MFN 08-655

Subject: **Response to Portion of NRC Request for Additional Information Letter No. 211 Related to ESBWR Design Certification Application – Human Factors Engineering - RAI Numbers 18.8-35 S03, 18.8-50 S01, 18.8-51 S01, 18.8-52 S01, and 18.8-59 S01**

**Response to NRC Request for Additional Information
Letter No. 211 Related to ESBWR Design Certification
Application
Human Factors Engineering
RAI Numbers
18.8-35 S03, 18.8-50 S01, 18.8-51 S01, 18.8-52 S01,
and 18.8-59 S01**

Figure 2 Human-System Interface Design Implementation Process.

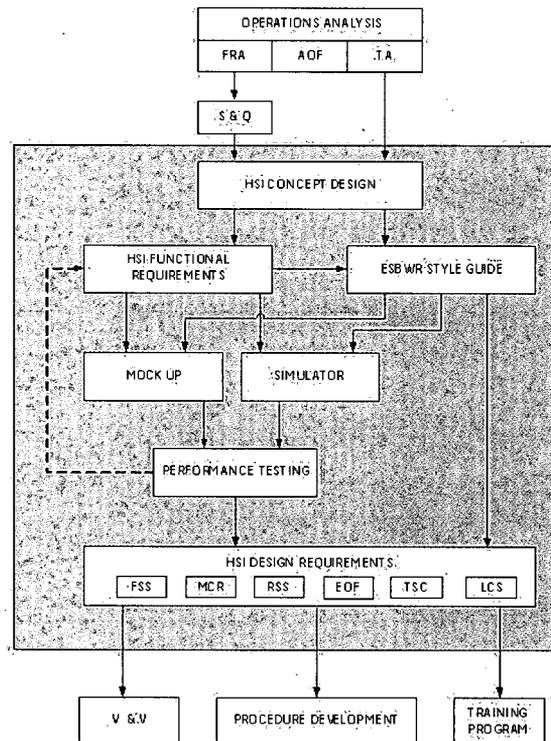
NEDO-33268, Revision 2, Section 3.1.3, states that the HFE team will develop functional requirements for the HSI that encompass the considerations identified in the two criteria for the Functional Requirements Specification. However, no additional information is provided. Additional clarification is needed as to how the requirements will be developed by the HFE team and how it will be documented. Note that the functional requirements are not identified in Section 5, Results.

To follow the guidelines regarding functional requirement specification as described in NUREG-0711, the team will follow the process illustrated in Figure 2 of NEDO-33268:

The HSI work instructions provide the methodology.

The HSI Style Guide is the design requirements document. Design requirements will be entered into an industry-standard software requirements tracking/traceability tool.

A new bullet, "Functional requirement specification from a Human-System Interface perspective" will be added to Section 5 Results.
